# Product Advisory

**Product Family:** Productivity Series  
**Part Numbers:** P2-RS, P3-RS, and P3-RX

**Number:** PA-PK-014  
**Date Issued:** 10/16/2017

**Subject:** **POTENTIAL SAFETY CONCERNS** with Multiple Remote Slave Bases

Figure 1

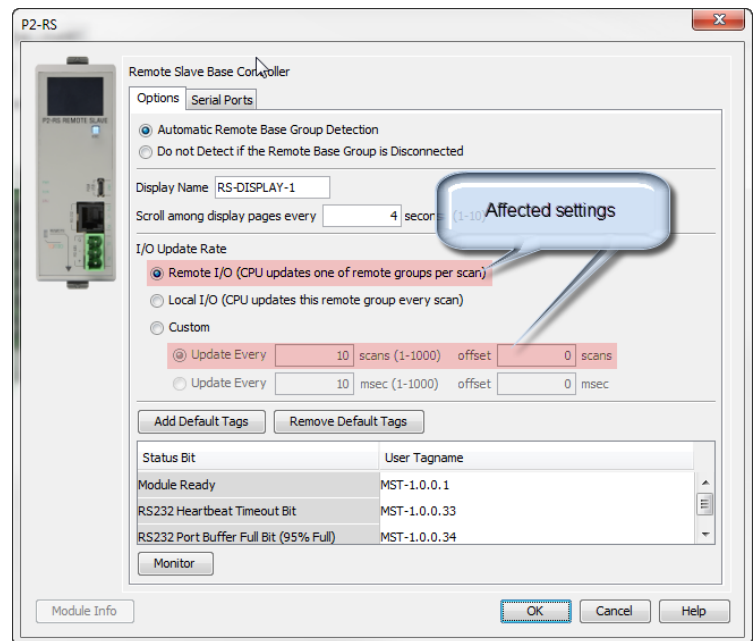
We have identified a problem that causes the CPU to stop updating the remote slave bases after a certain amount of time (~2 billion scans). This will cause the I/O in the remote bases to freeze in their last known state until you cycle power to the CPU or download the project.

This problem is only reproducible in two (2) of the four (4) possible I/O Update Rate configurations (shown in Figure 1). The default selection (Remote I/O) is one of the affected settings.

Version 2.4.5.1 of the Productivity Suite programming software corrects this issue. We recommend that anyone using the Productivity PLCs upgrade their software to v2.4.5.1 (or later).

Figure 2

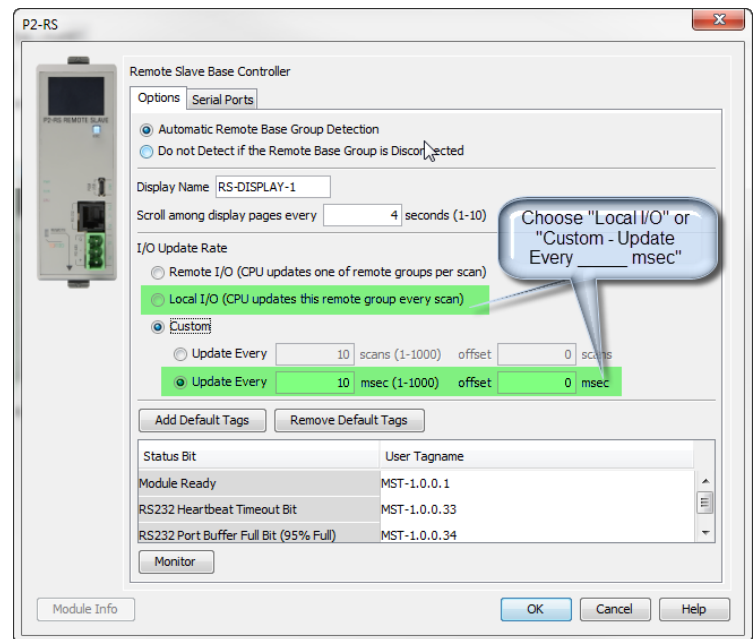
If you have a remote base(s) in your hardware configuration, you should verify the I/O Update Rate setting immediately. Setting your Remote base I/O Update Rate to one of the following will ensure proper operation (shown in Figure 2 below):

- Local I/O (CPU updates the remote group every scan)  
**Note: Depending on the number of remote bases you have in your system, this setting will likely impact your scan time.**
- Custom - Update Every \_\_\_\_\_ msec (1 – 1000)

If you determine that your remote base(s) do not need to be updated each scan, or you cannot afford the impact to your scan time, selecting Custom and specifying a time delay greater than your current scan rate may lessen the burden on your CPU scan.
